Preface

An Addendum to the *Groundwater Flow Model of Corrective Action Units 101 and 102: Central and Western Pahute Mesa, Nevada Test Site, Nye County, Nevada, S-N/99205--076, Revision 0* (June 2006) was prepared to address review comments of this final document by the Nevada Division of Environmental Protection (NDEP) in a letter dated July 19, 2006. The Addendum includes revised pages that address NDEP review comments and comments from other document users. Change bars are included on these pages to identify where the text was revised.

Figure 5-14
Histogram of Weighted Head Residuals - Base HFM,
No Depth Decay, No Anisotropy

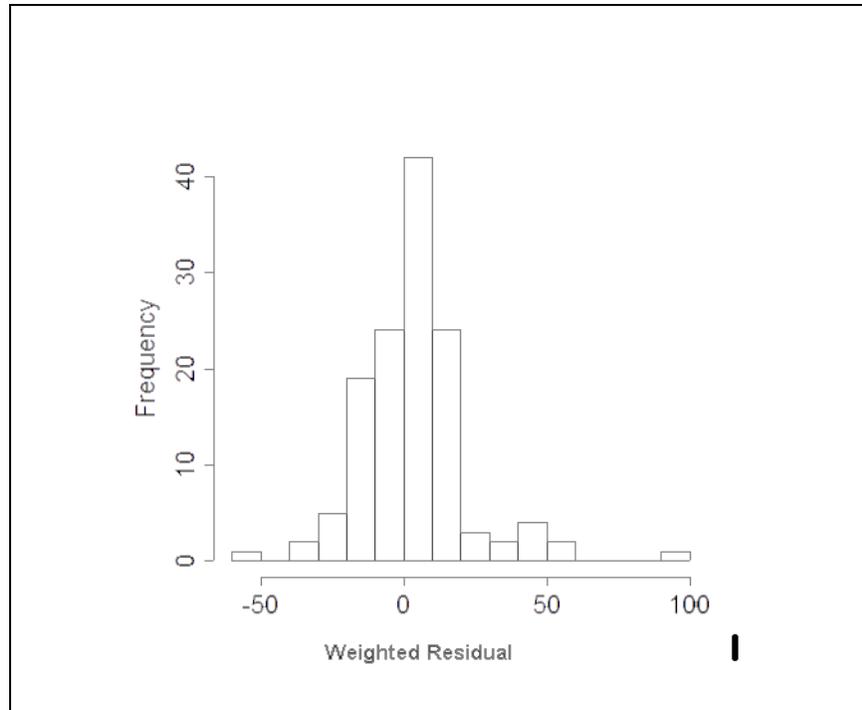
Note: As part of this Addendum, Figure 5-14 replaces the original Figure 5-14 that appears in the *Groundwater Flow Model of Corrective Action Units 101 and 102: Central and Western Pahute Mesa, Nevada Test Site, Nye County, Nevada, S-N/99205--076* (June 2006).

Figure 5-15
Post Plot of Weighted Well and Spring Head Residuals - Base HFM,
No Depth Decay, No Anisotropy

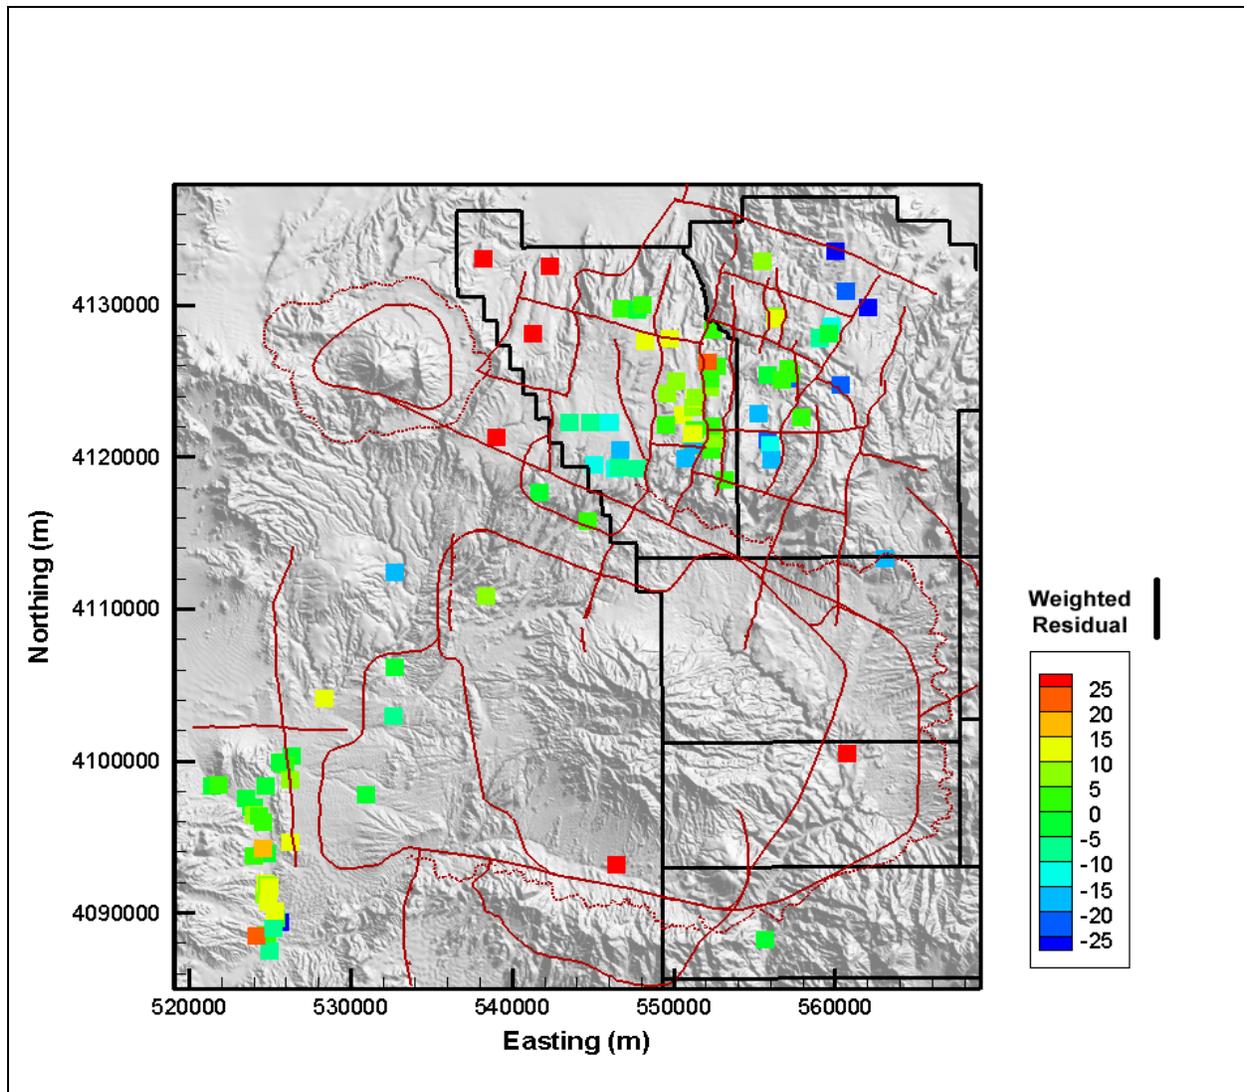
Note: As part of this Addendum, Figure 5-15 replaces the original Figure 5-15 that appears in the *Groundwater Flow Model of Corrective Action Units 101 and 102: Central and Western Pahute Mesa, Nevada Test Site, Nye County, Nevada, S-N/99205--076* (June 2006).

Figure 5-24
Post Plot of Weighted Well and Spring Head Residuals - Base HFM,
No Depth Decay, No Anisotropy

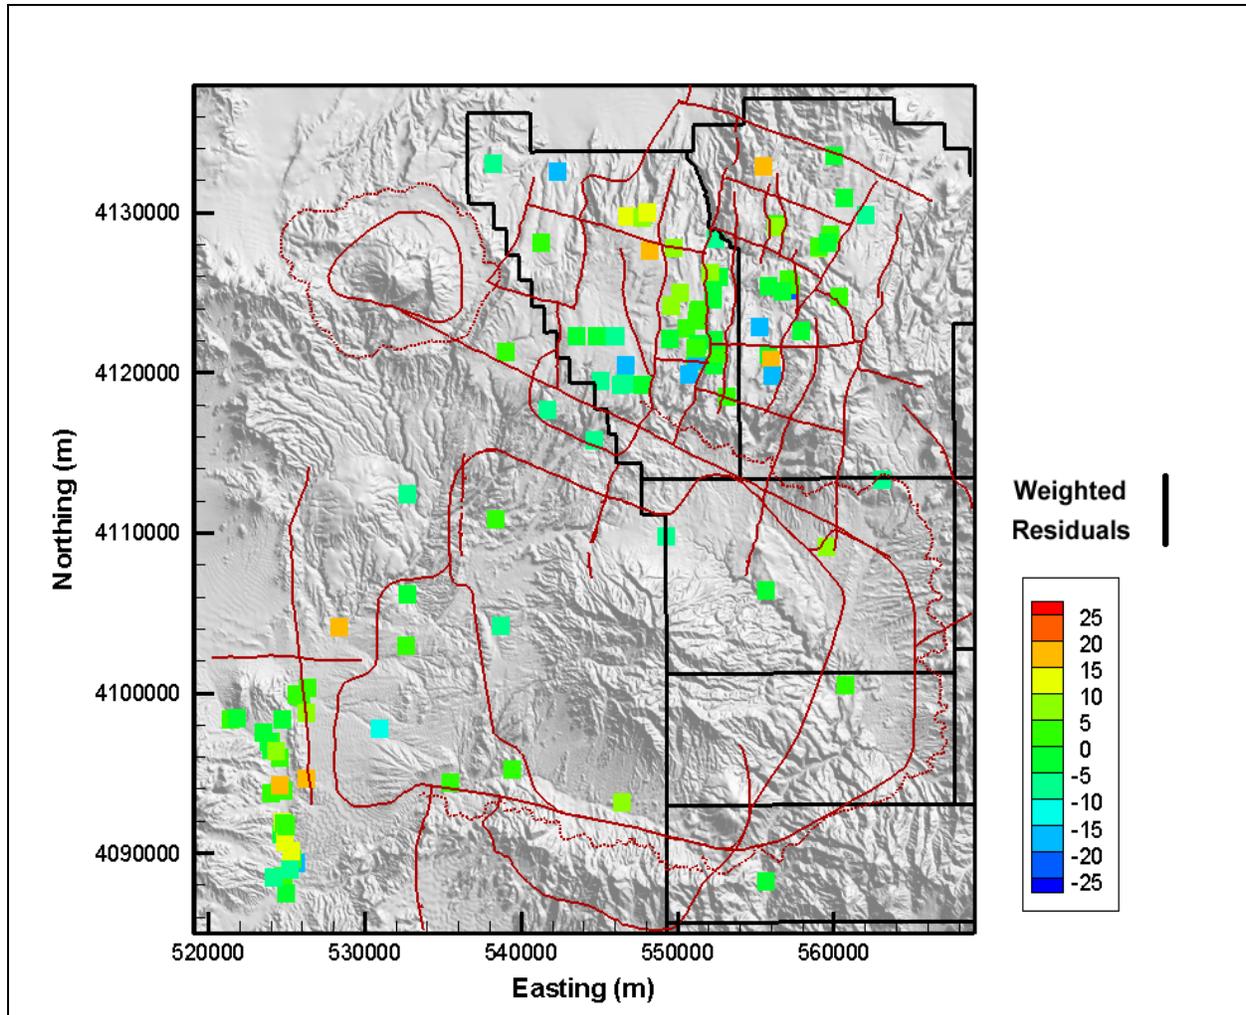
Note: As part of this Addendum, Figure 5-24 replaces the original Figure 5-24 that appears in the *Groundwater Flow Model of Corrective Action Units 101 and 102: Central and Western Pahute Mesa, Nevada Test Site, Nye County, Nevada, S-N/99205-076* (June 2006).

Figure 5-44
Simulated Heads Near the Purse Fault for BN-MME-SDA

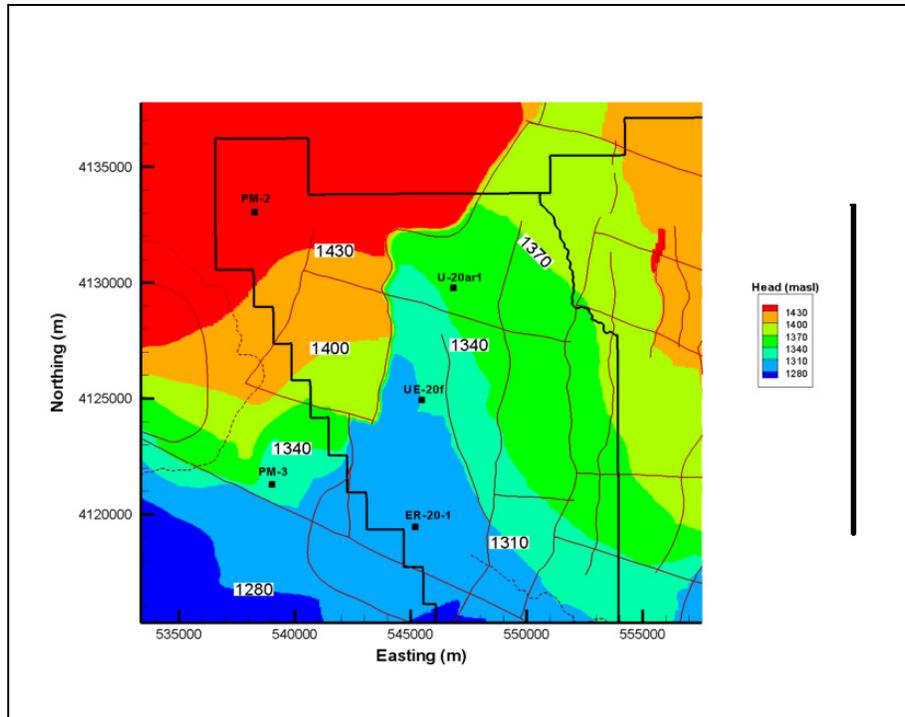
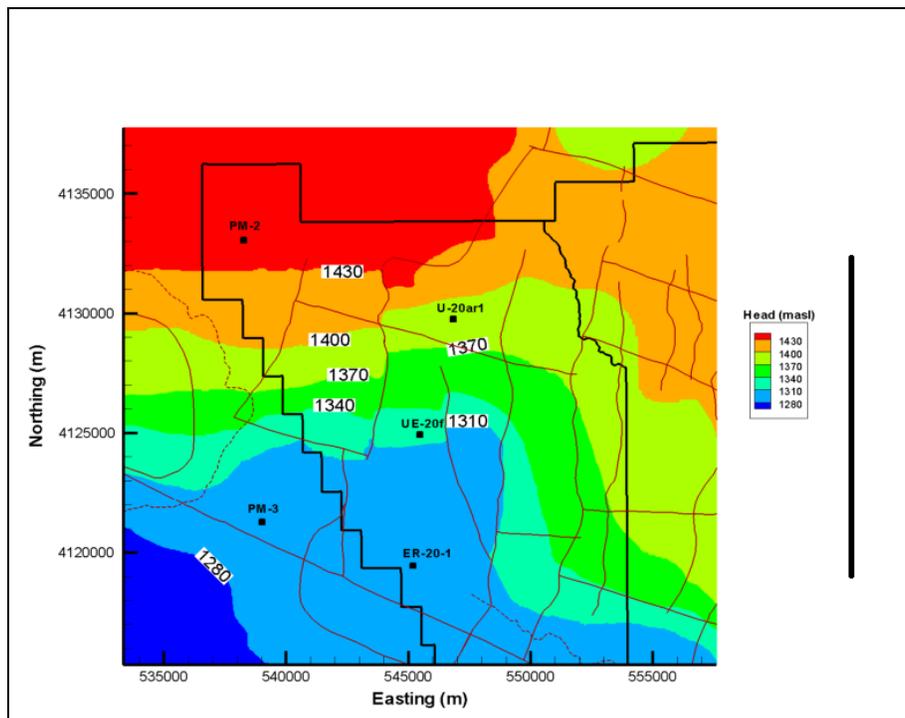
Note: As part of this Addendum, Figures 5-44 and 5-45 replace the original Figures 5-44 and 5-45 that appear in the *Groundwater Flow Model of Corrective Action Units 101 and 102: Central and Western Pahute Mesa, Nevada Test Site, Nye County, Nevada*, S-N/99205--076 (June 2006).

Figure 5-54
Comparison of Model and Estimated Permeabilities for PBRCM and YMCFCM

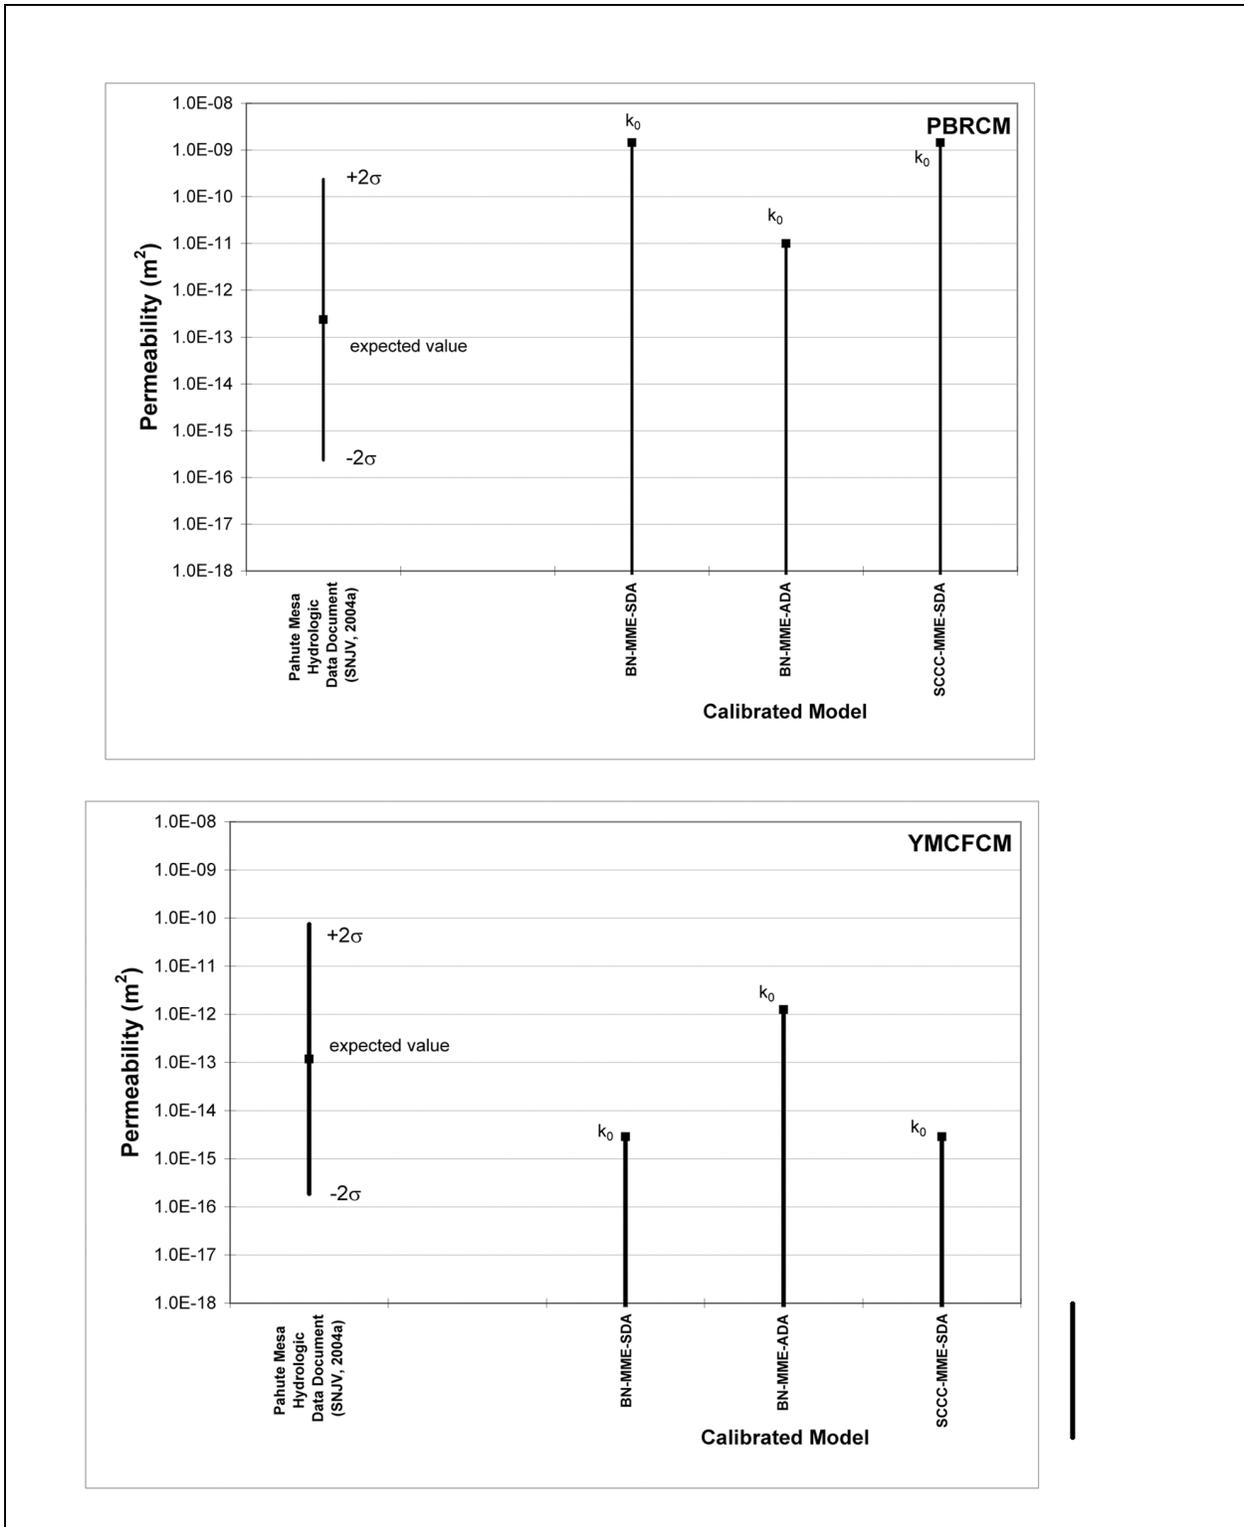
Note: As part of this Addendum, Figure 5-54 replaces the original Figure 5-54 that appears in the *Groundwater Flow Model of Corrective Action Units 101 and 102: Central and Western Pahute Mesa, Nevada Test Site, Nye County, Nevada, S-N/99205-076* (June 2006).
